S196-09/10
2302.1

Proposed Change as Submitted

2308.3.2, Figure 2308.3.2(1) (New), Figure 2308.3.2(2) (New)

FIGURE 2308.3.2 (1)
BRACED WALL PANEL TOP PLATE CONNECTION

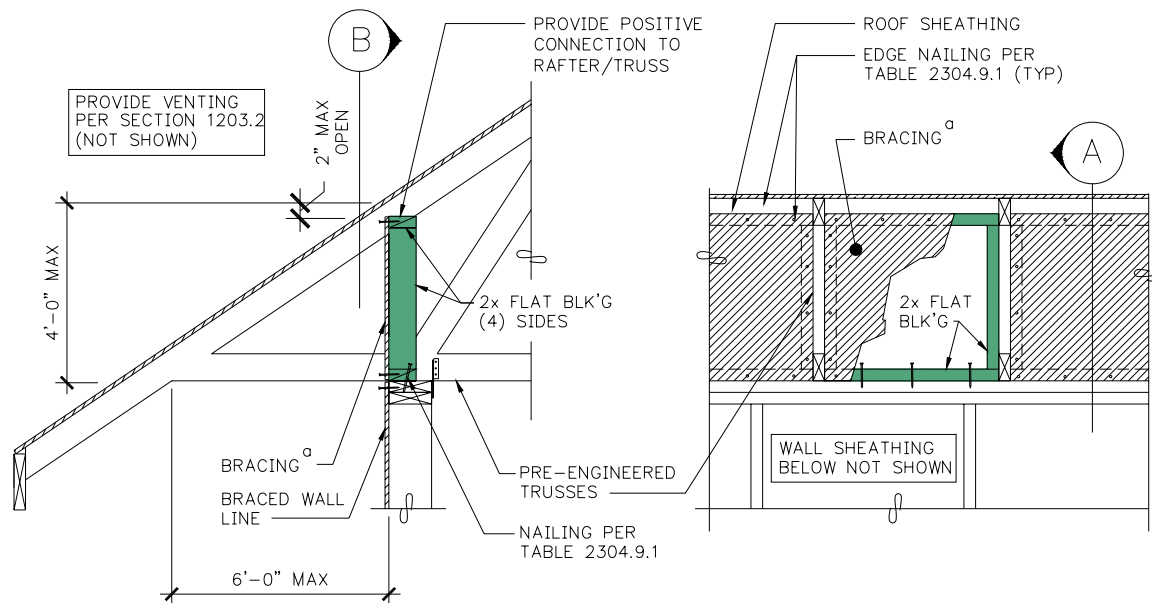
- 2.1 In accordance with Figure 2308.3.2 (1)
 - 2.2 In accordance with Figure 2308.3.2 (2)
 - 2.3 With full height engineered blocking panels designed for values listed in AF&PA WFCM.

Reason: The 2006 IBC had fairly clear wording that the diaphragms need to be connected to the braced wall lines. With the approval of proposal 2008/2009 S224 the 2009 language was modified to make the purpose even more clear in that the connection is required to resist wind and seismic (lateral) forces. This proposal merely provides prescriptive methods to accomplish the connection whether with solid blocking or when solid blocking doesn't work.

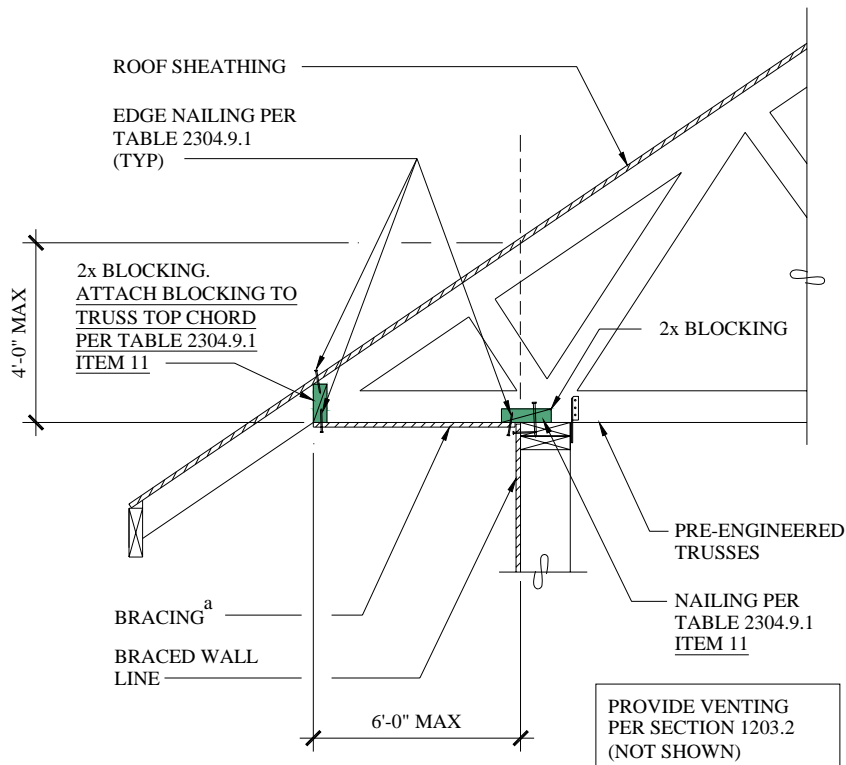
Modify the proposal as follows:

2308.3.2 Braced wall line connections. Wind and seismic lateral forces shall be transferred from the roofs and floors to braced wall lines and from the braced wall lines in upper stories to the braced wall lines in the story below in accordance with this section.

Braced wall line top plates shall be fastened to joists, rafters or full-depth blocking above in accordance with Table 2304.9.1, Items 11, 12, 15 or 19 as applicable based on the orientation of the joists or rafters to the braced wall line. Braced wall line bottom plates shall be connected to joists or blocking below in accordance with Table 2304.9.1, Item 6, or to foundations in accordance with Section 2308.3.3. At exterior gable end walls, braced wall panel sheathing in the top story shall be extended and fastened to roof framing where the spacing between parallel exterior braced wall lines is greater than 50 feet (15 240 mm).

FIGURE 2308.3.2 (1)
BRACED WALL PANEL TOP PLATE CONNECTION.

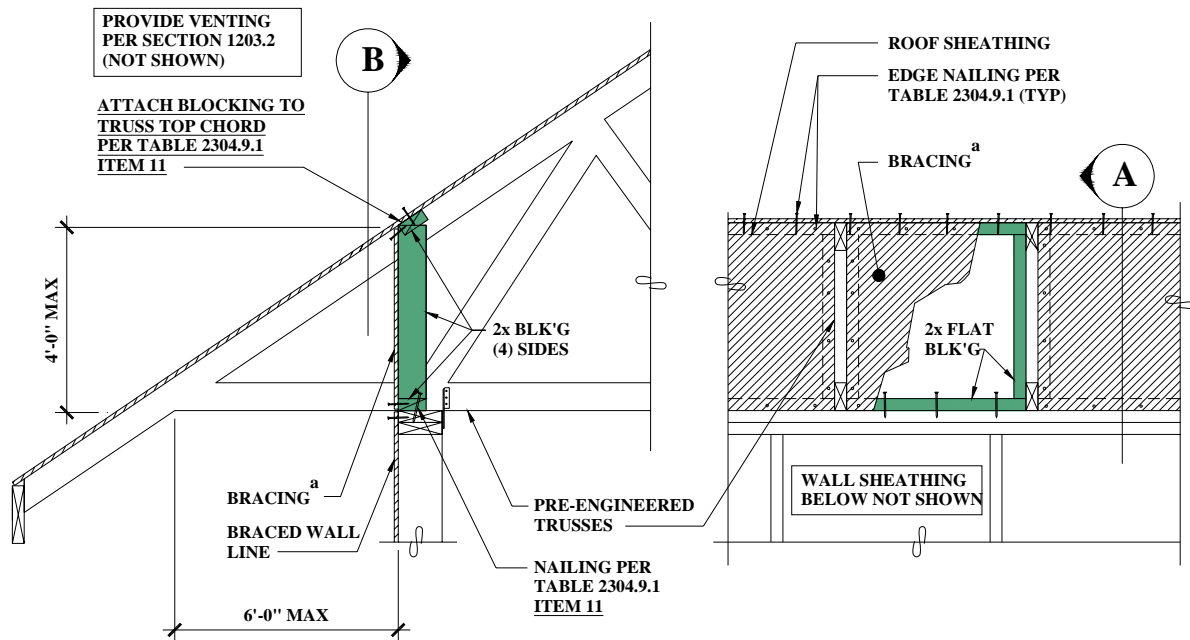
- ~~2.4~~ 1. In accordance with Figure 2308.3.2 (1)
 - ~~2.2~~ 2. In accordance with Figure 2308.3.2 (2)
 - ~~2.3~~ 3. With full height engineered blocking panels designed for values listed in AF&PA WFCM.
